CONTRACT CHANGE ORDER NO. \_\_\_\_\_  
SHEET \_\_\_\_\_ OF \_\_\_\_\_

DIST	COUNTY	ROUTE	KILOMETER TOTAL PROJECT	POST TOTAL PROJECT	SHEET No	TOTAL SHEETS
04	SF	80	13.2/13.9		96R4	1204

**UNDERGROUND DUCT BANKS AND MANHOLES**  
SCALE 1:200

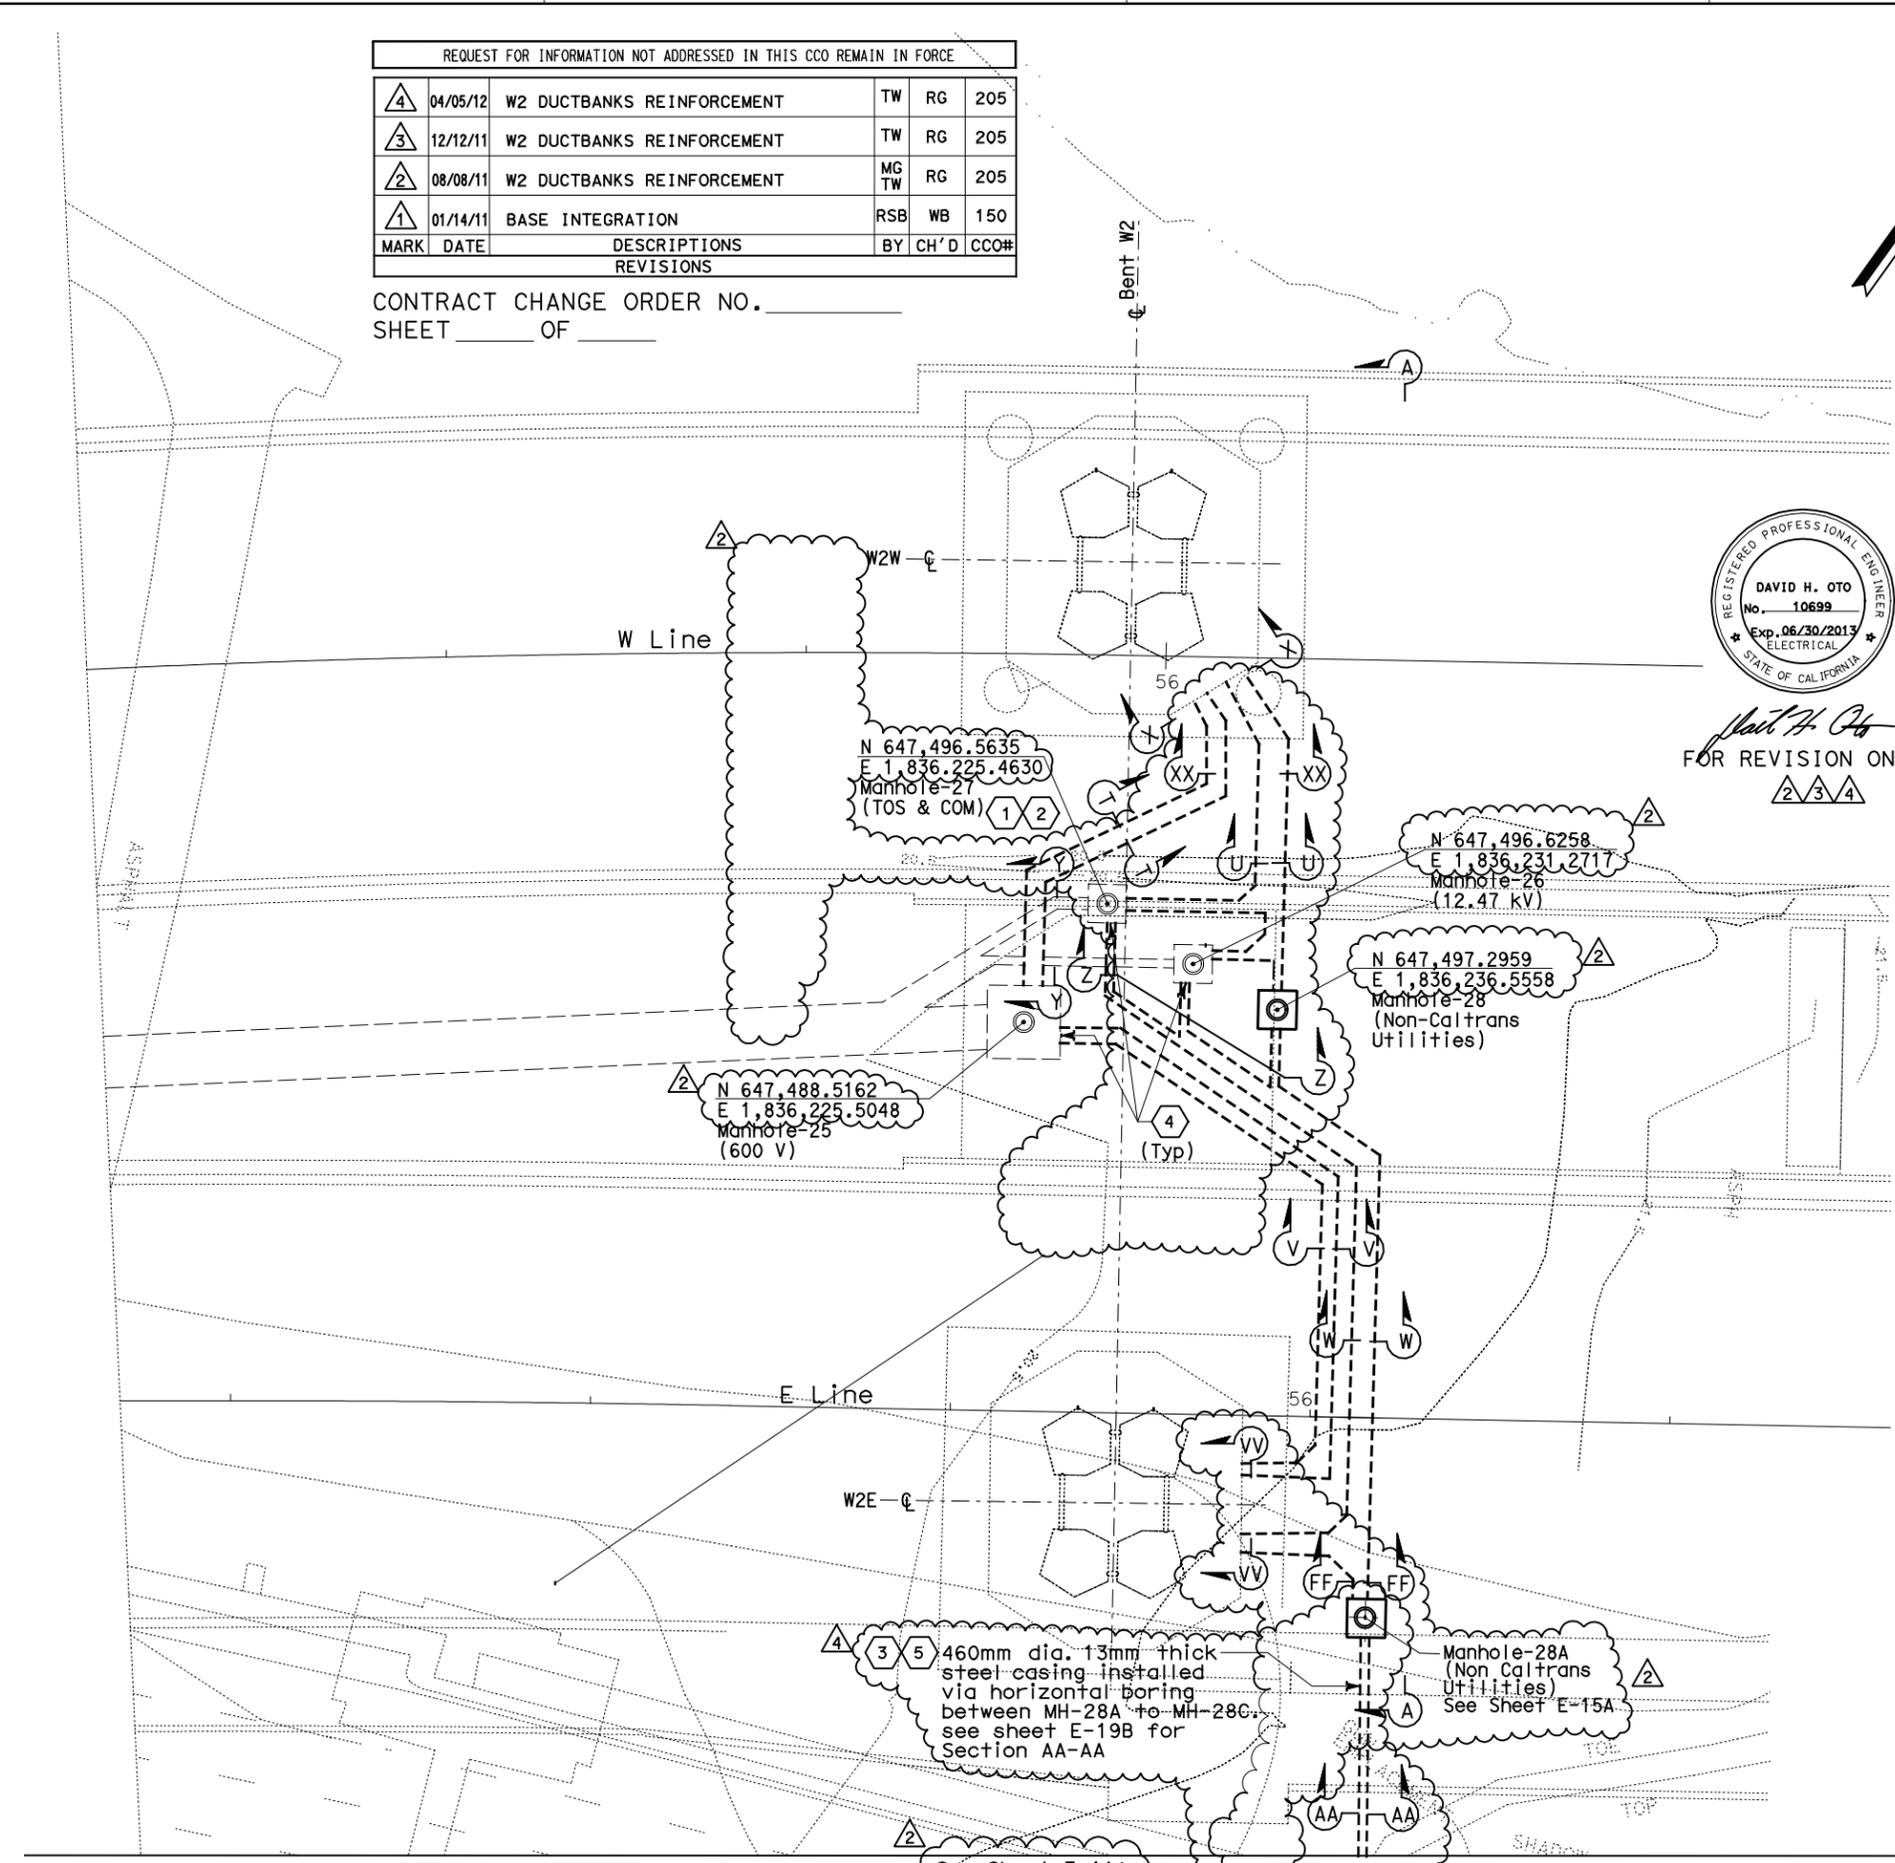
REQUEST FOR INFORMATION NOT ADDRESSED IN THIS CCO REMAIN IN FORCE					
MARK	DATE	DESCRIPTIONS REVISIONS	BY	CH'D	CCO#
4	04/05/12	W2 DUCTBANKS REINFORCEMENT	TW	RG	205
3	12/12/11	W2 DUCTBANKS REINFORCEMENT	TW	RG	205
2	08/08/11	W2 DUCTBANKS REINFORCEMENT	MG TW	RG	205
1	01/14/11	BASE INTEGRATION	RSB	WB	150
